**I. Independent Review of Selected Sections of the
2009 West Valley Decommissioning Final
Environmental Impact Statement**

for the
New York State Energy Research and Development Authority
November 20, 2009

**II. Independent Review of the Draft Environmental
Impact Statement for Decommissioning and/or
Long-Term Stewardship at the West Valley
Demonstration Project and Western New York
Nuclear Service Center**

for the
New York State Energy Research and Development Authority
September 3, 2008

Figure 6 (Figure 2-36 from Sitewide report) Conceptual Plan for Site-wide Erosion Controls

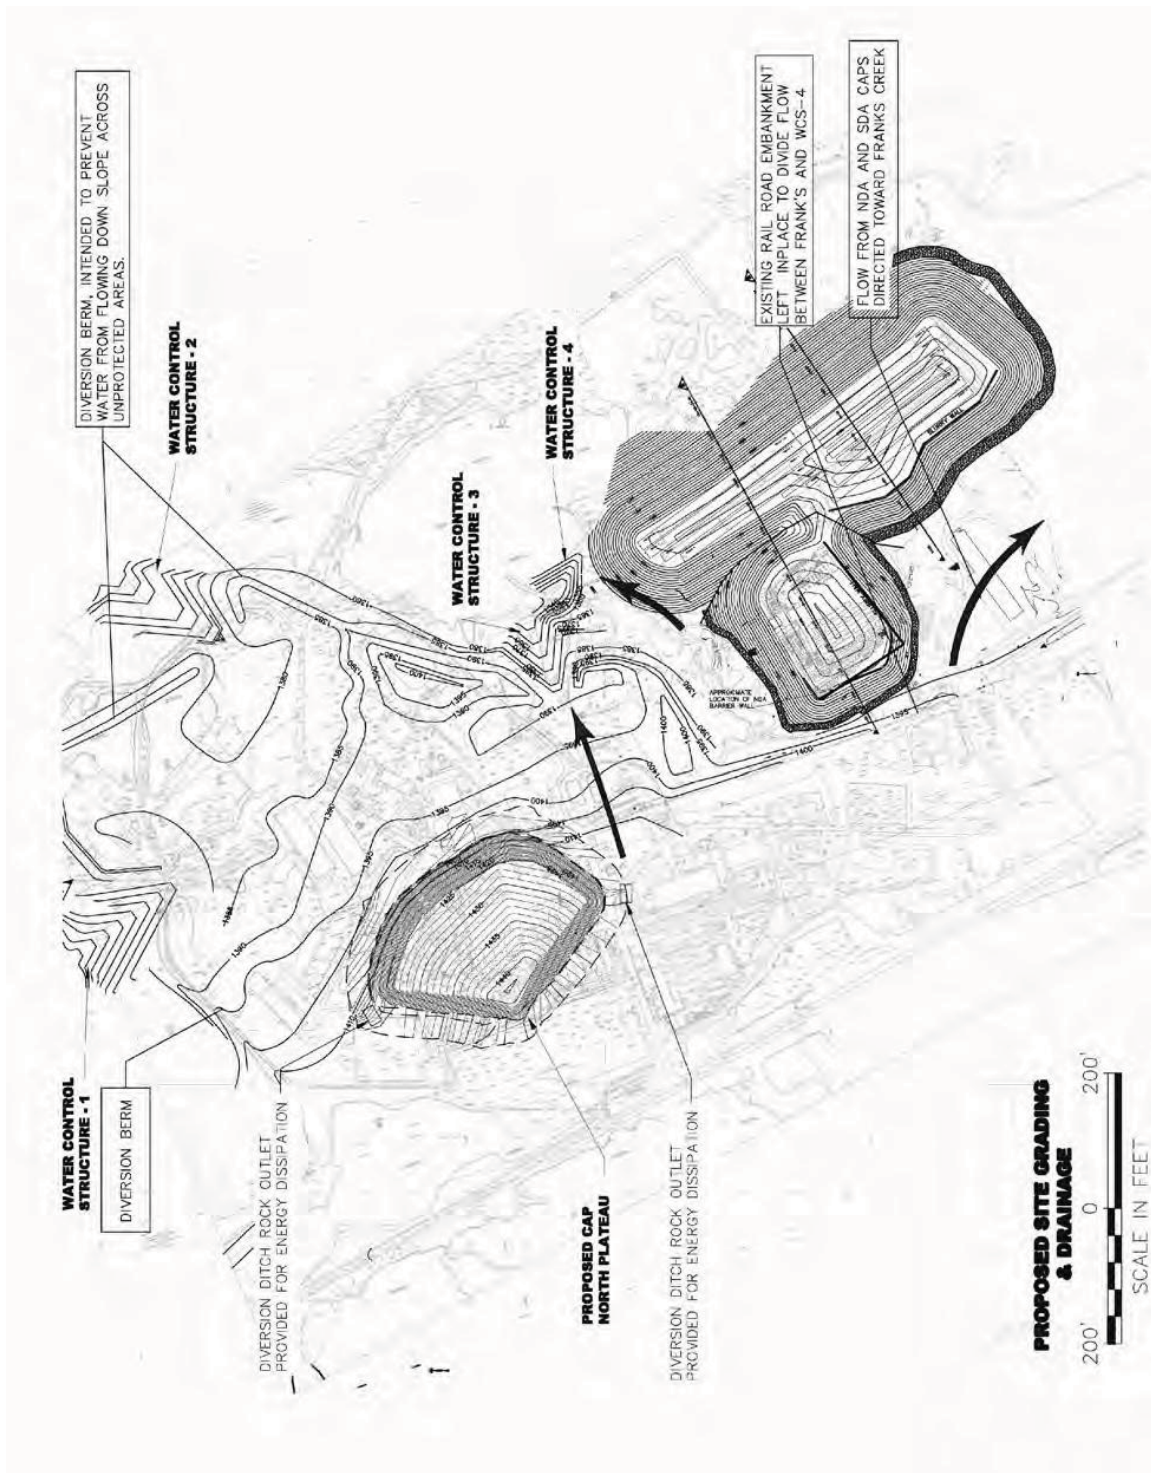
The primary purpose of installing diversion berms is to control runoff on the North and South Plateaus, and direct the flow to the areas that are appropriately protected against erosion. Diversion berms are intended to mitigate the free flow of runoff over the edge of the plateaus in unprotected areas. The diversion berms running along the top of the Quarry Creek and Franks Creek banks would direct flow to Water Control Structure 1 (WCS1) and WCS2 indicated in Figure 6.

be installed are the NP1 Gully, NP2 Gully, Lagoon Creek Gully, SDA Gully, and (possibly) the NDA Gully (see Figure 6).

Figure 3-5. Environmental Airborne Releases by Implementation Year

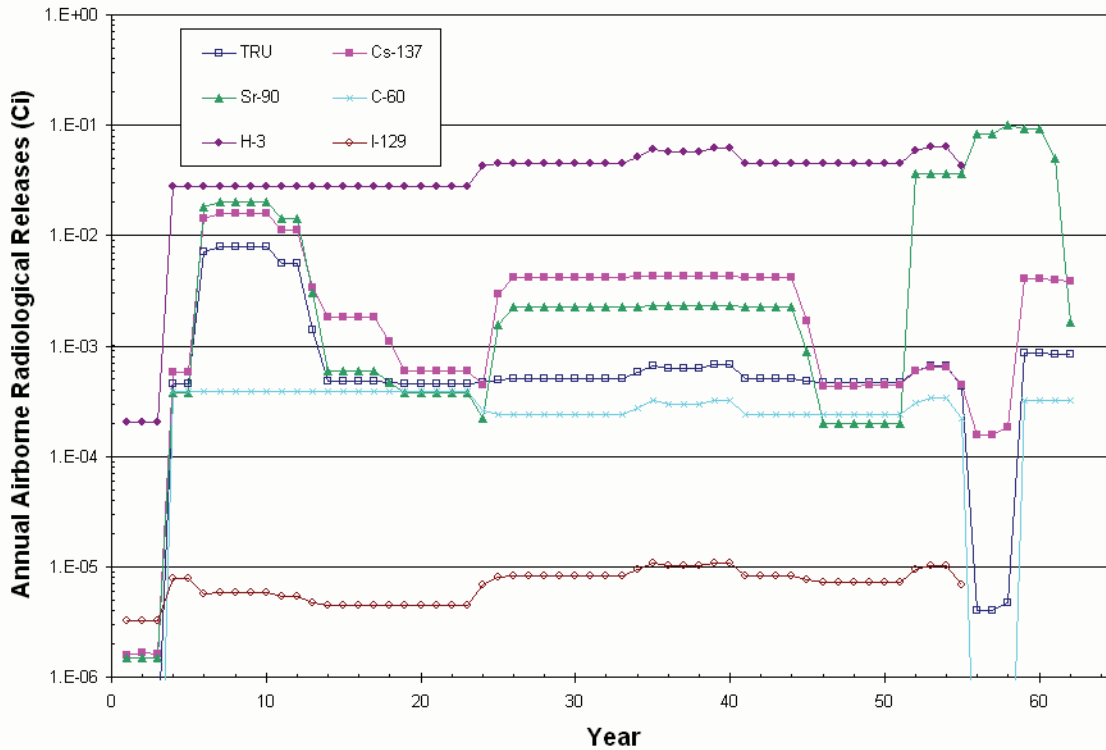
The wisdom of double containment for complete sites is questionable since the atmospheric releases are only 0.1 curies per year of tritium and barely 0.01 of other nuclides are being released to the atmosphere. After 50 years Sr-90 spikes (no explanation is given for that figure except that it involves the removal of the North Plateau Groundwater Plume but does not say what preventive measures such as wetting the soils and noting that strontium does not volatilize) but is still less than 0.1 curies per year. (Figure 3-5 of the STRA.)

Figure 2-28. Conceptual NDA Environmental Enclosure

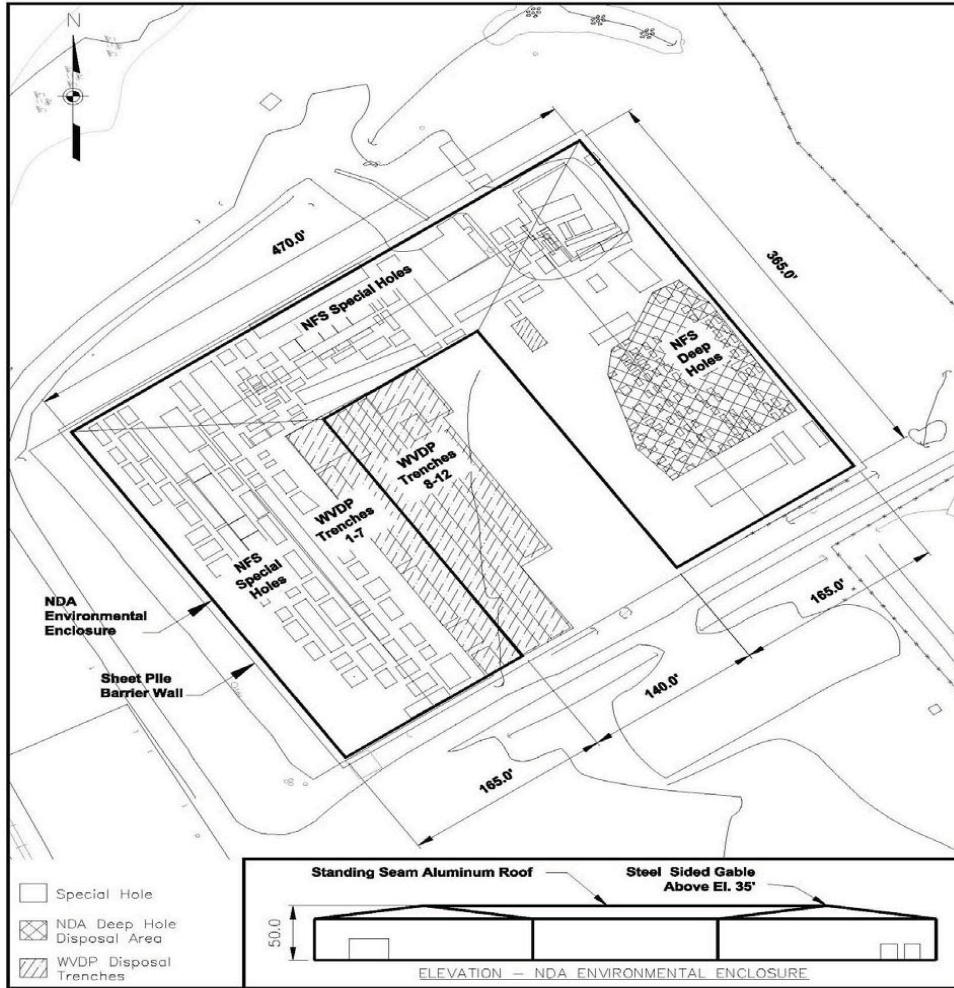
The exact dimensions of the Modular Shielded Environmental Enclosure are unclear as the Perspective View has no dimensions and the Wall and Panel Sections do not show all of the measurements. It is surprising that these structures will not be reused at the SDA but will be demolished at the conclusion of activities.
